Interactive comment on “CAMELS-BR: Hydrometeorological time series and landscape attributes for 897 catchments in Brazil” by Vinícius B. P. Chagas et al.

Reply to comments by Reviewer #1, Wouter Knoben.

Fig. 1. Figure R1. Example of attributes with symbols scaling with catchment size in the previous manuscript, in the revised manuscript, and with symbols not scaling with catchment size.

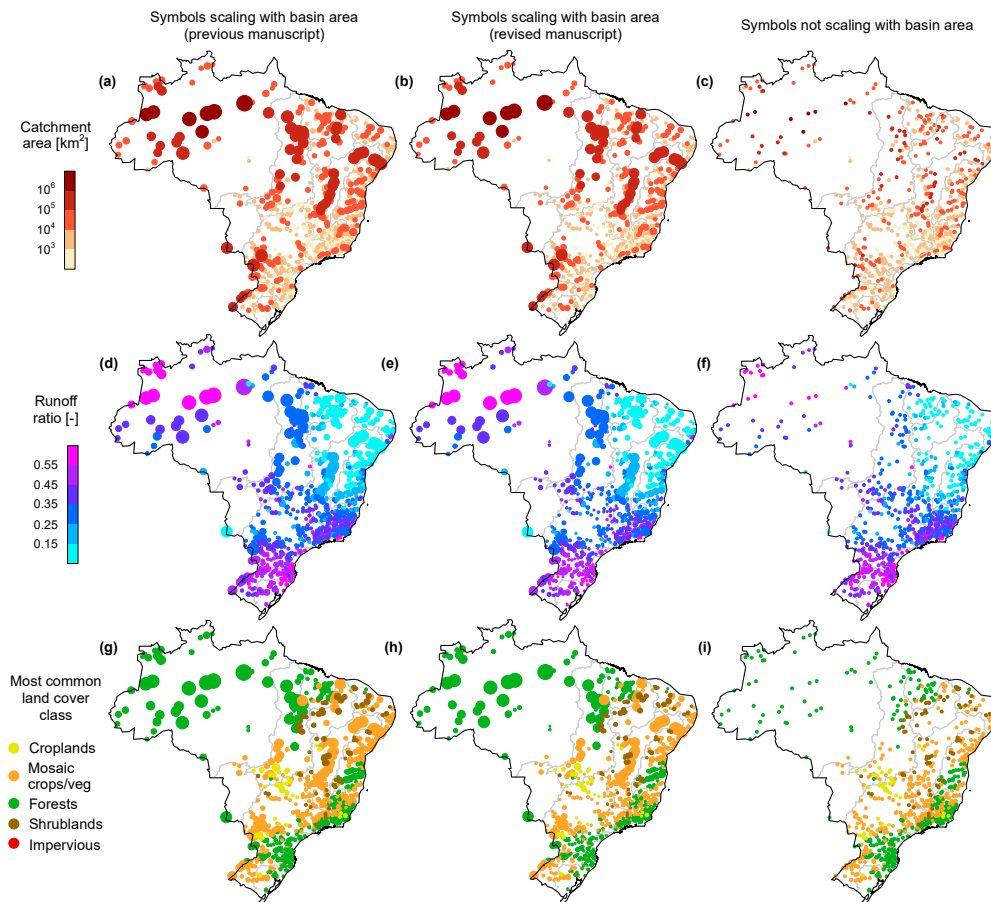
Comment #19: Figures: it is a bit difficult to make out any details in the figure in the south-east region, where gauge density is high. It might be worthwhile to not scale the data points according to catchment size (although keeping this scaling in Figure 1 is quite informative) in the data plots.

Reply: We have tried your suggestion and it seems that not scaling the symbols with catchment area did not solve this problem. It seems that it also hinders the visualization in low gauge density regions (see Fig R1c, f, i). Although the southeastern region has a high gauge density, those are usually the smallest catchments in the country (Fig R1a). We believe that scaling the symbols with catchment size facilitates the data visualization, particularly in the southeast.

We tried to improve the visualization by decreasing the size of all symbols but keeping them scaling with catchment size. In this way, it enhanced the visualization of high gauge density regions without hindering the visualization of low gauge density regions (Fig R1a-b, d-e, g-h). The following Figures were modified: Fig 1, 4, 5, 6, 7, 8, 9, and 10.

Fig. 2. Figure R2: Gauges selected using three different criteria.

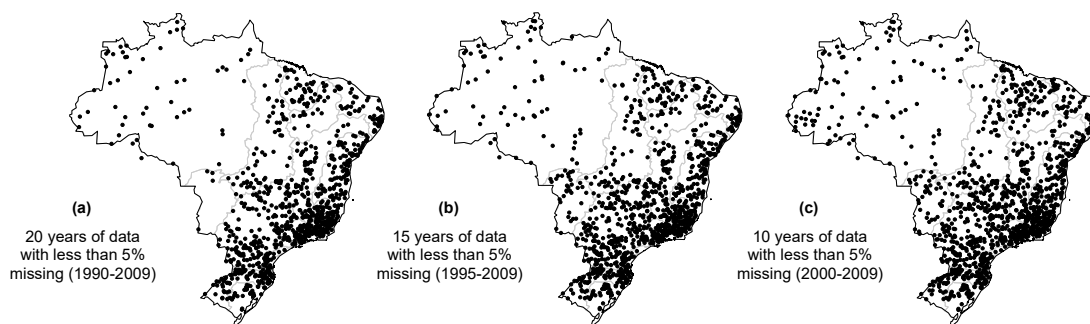
Comment #31: Is there a possibility to improve the density of watersheds in the western part of the country ? I understand that the spatial density of observations/stations is lower and that these stations might have been excluded for some reasons ? But, hypotheses of exclusion might be relaxed in regions where station density is lower, in order to have a more homogeneous spatial coverage of the county ?

Reply: Even if we use a more relaxed selection criterion, the gauge density increase would be noticeable only in a small portion of the western part of the country (see Fig. R2). If we consider all basins with 10 years of data and less than 5% missing (from

2000-2009), only the upper Paraguay basin would have increased gauge density (Fig. R2c). Changes in other regions, such as the Amazon, Tocantins-Araguaia, and lower Paraguay, would barely be noticeable.

Changing to a more relaxed selection criterion would remove the consistency among CAMELS-BR and the other CAMELS datasets. Additionally, reducing the coverage period would lead to substantial increases in the uncertainty of climatic and hydrological indices. We are aware that the users of the dataset might want to consider those additional catchments in further research, which is why we have included streamflow data from all 3679 catchments in Brazil in the manuscript.
